**DELEGATED AUTHORITY CONSULTATION REPORT 8058**

**TRAFFIC ORDERS – CONNAUGHT VILLAGE GREEN**

**AMENDMENTS TO PARKING PROVISIONS AND WAITING AND LOADING RESTRICTIONS**

**(Drawing Nos. 70091640-WSP-P01-X-DR-HI-1202 and 1203 Revs S2 P01)**

Image 2

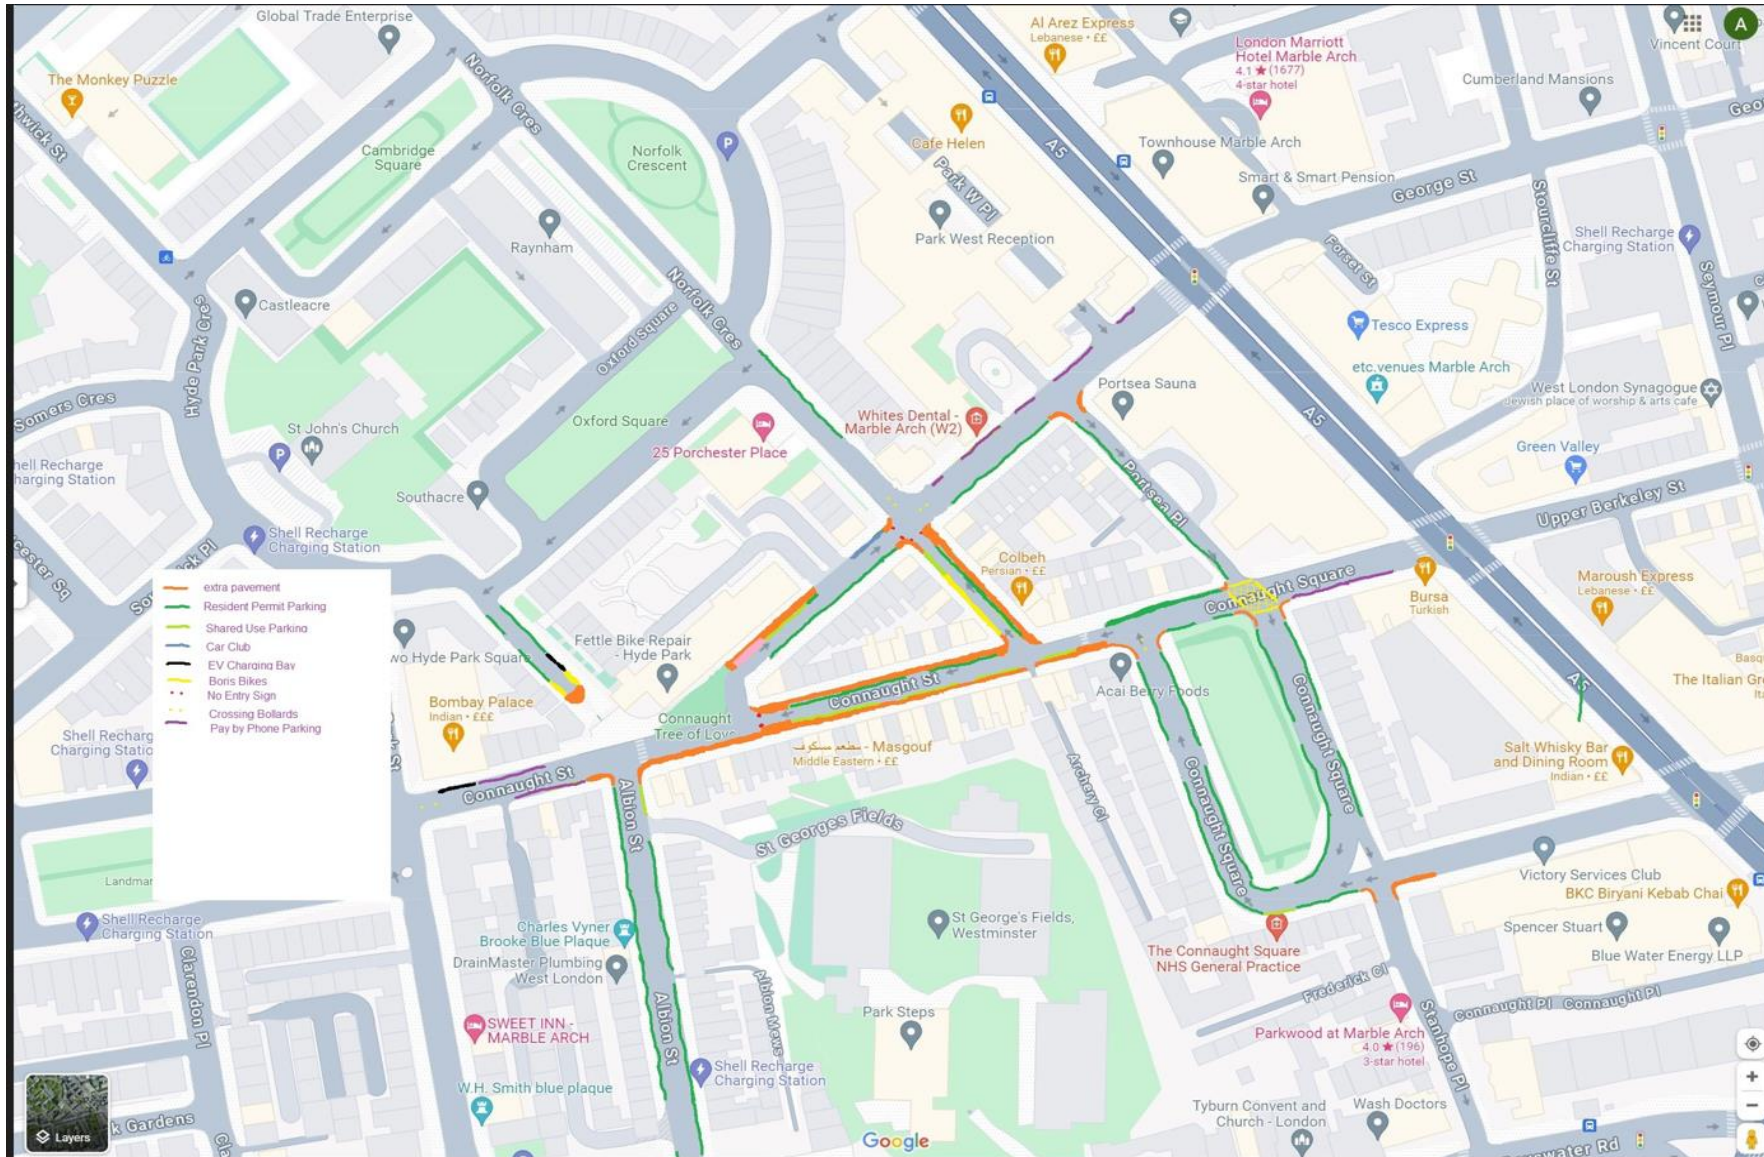
“Proposed Traffic Connaught Village”. See Item 24 in Appendix A to this report

Image 3

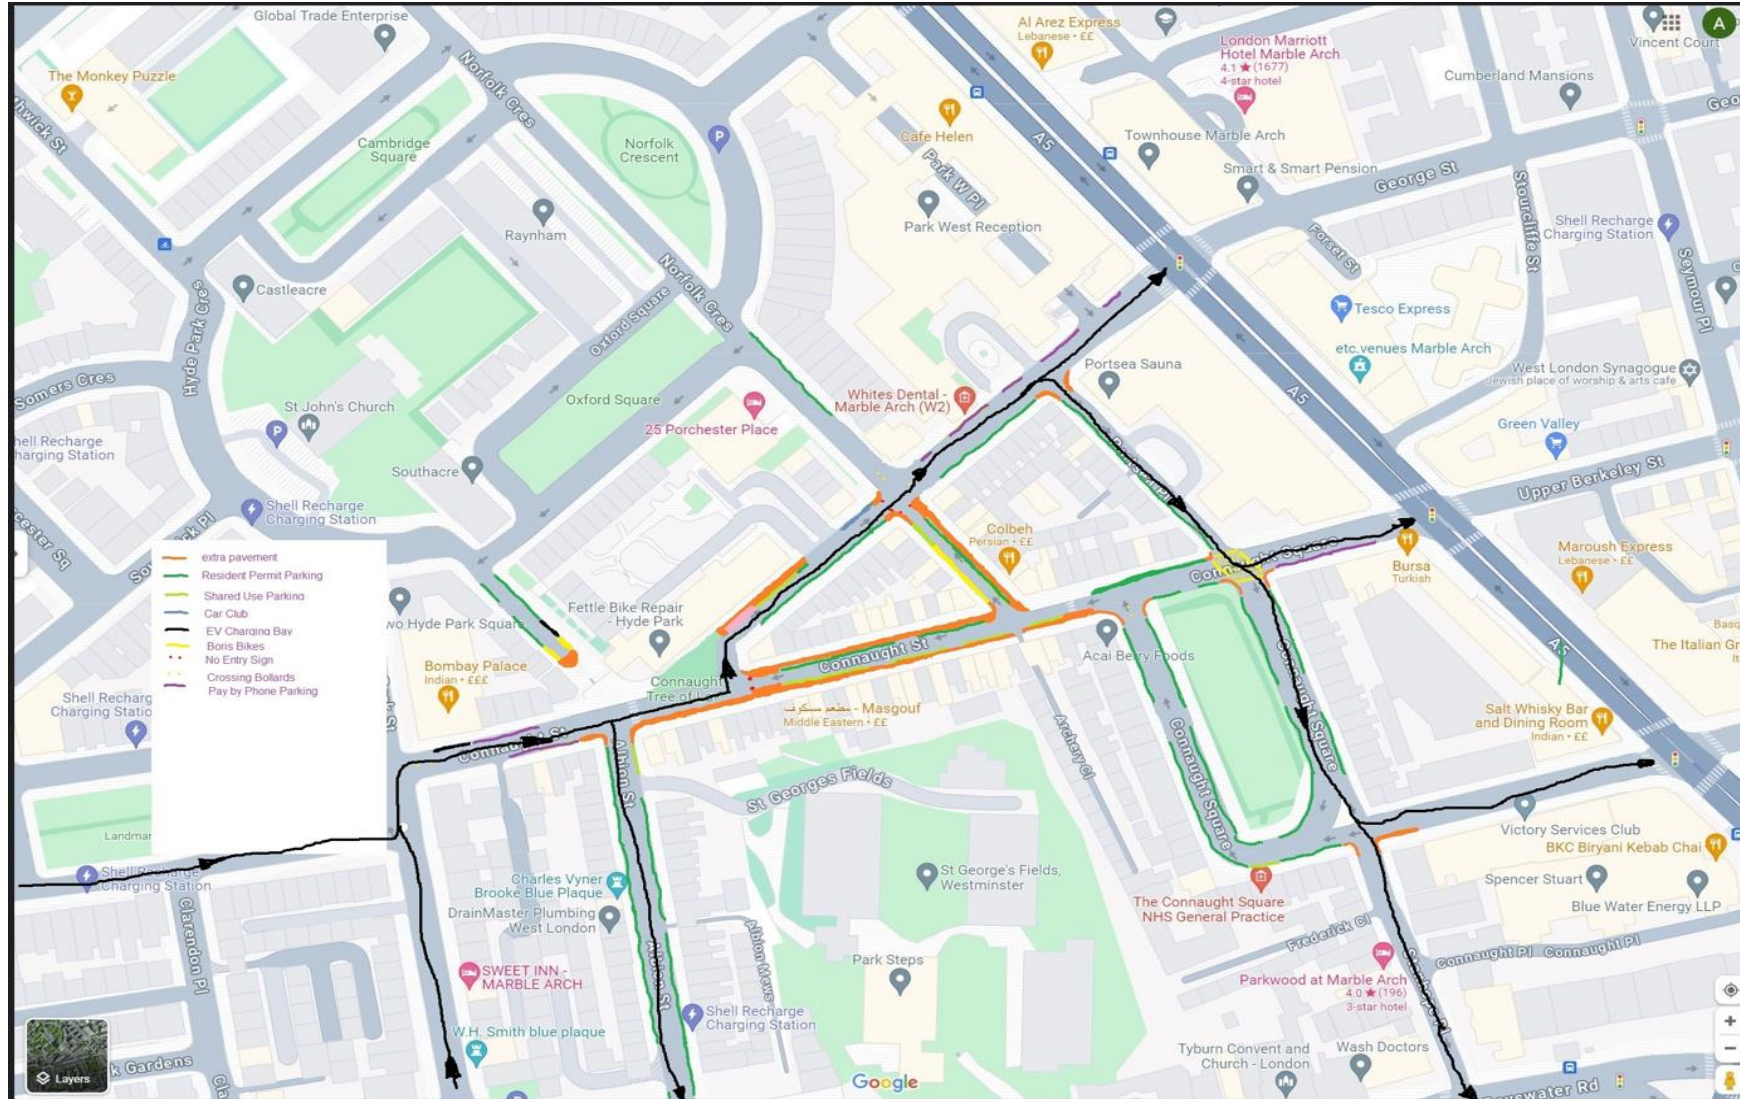
“Connaught Village Morning Rush”. See Item 24 in Appendix A to this report

Image 4

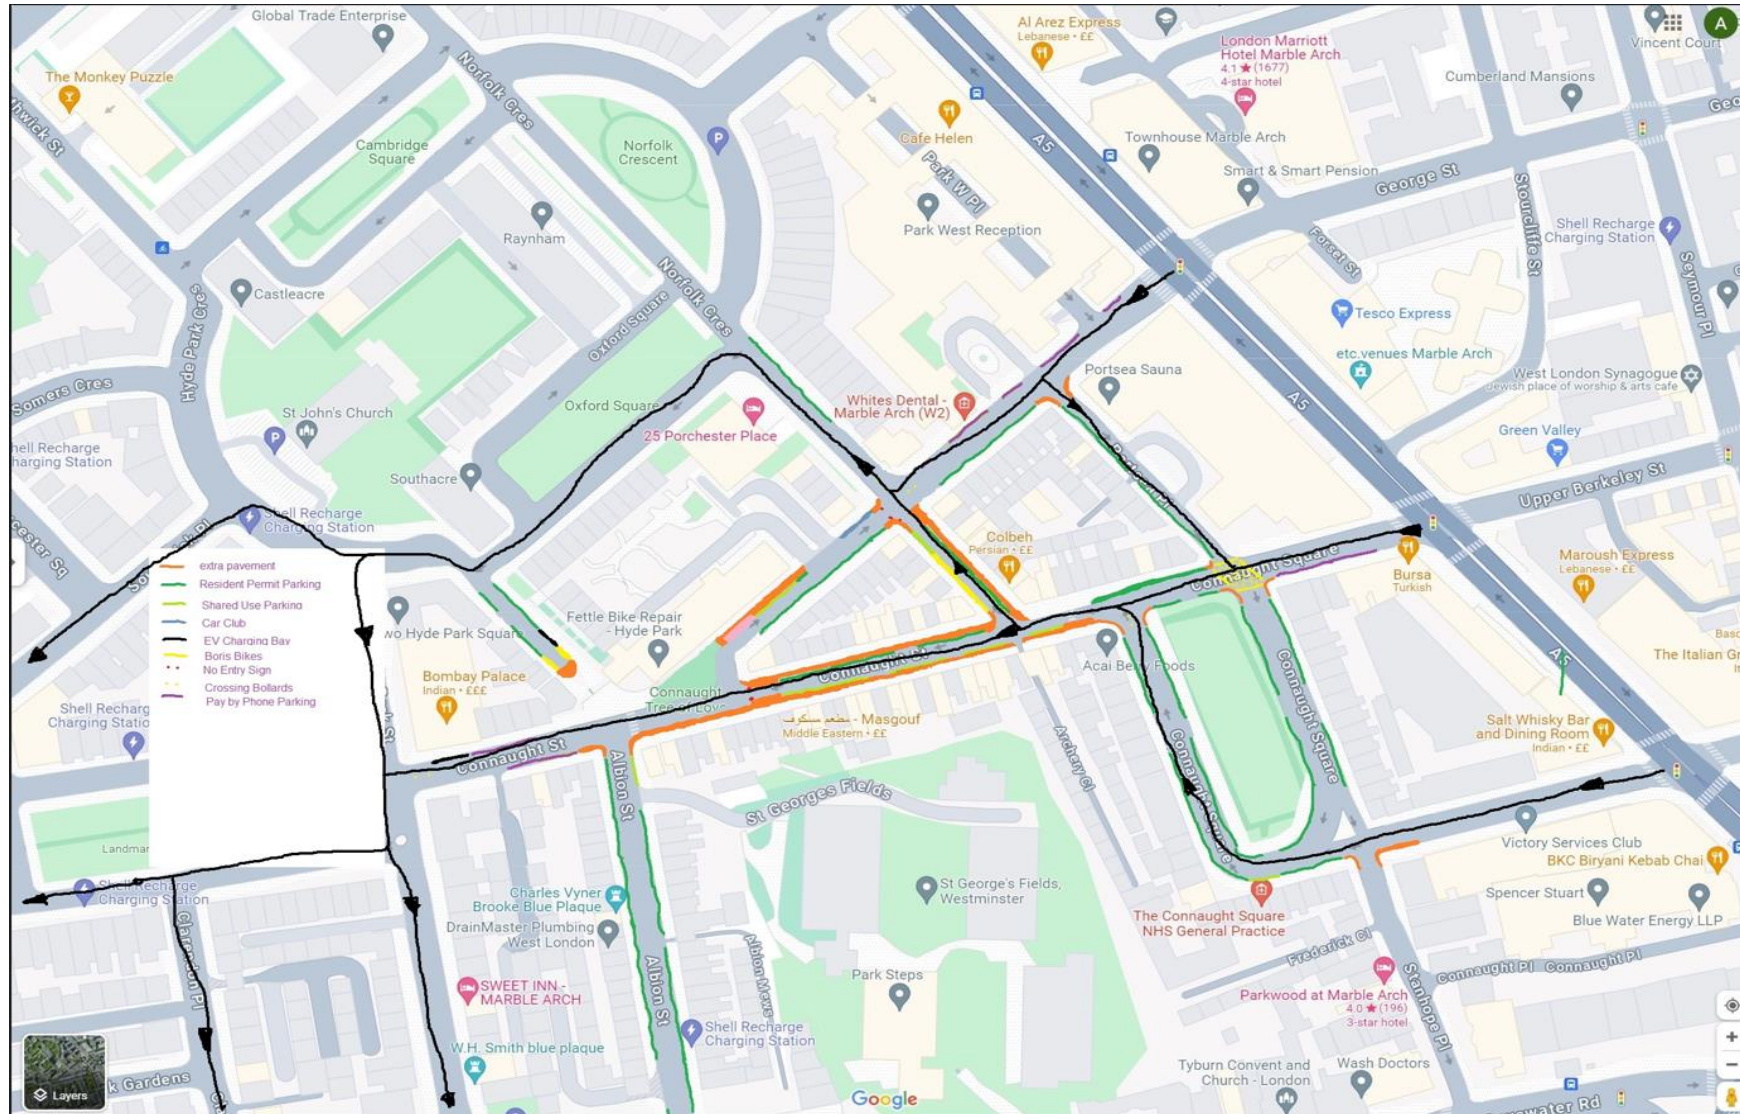
“Connaught Village Evening Rush”. See Item 24 in Appendix A to this report
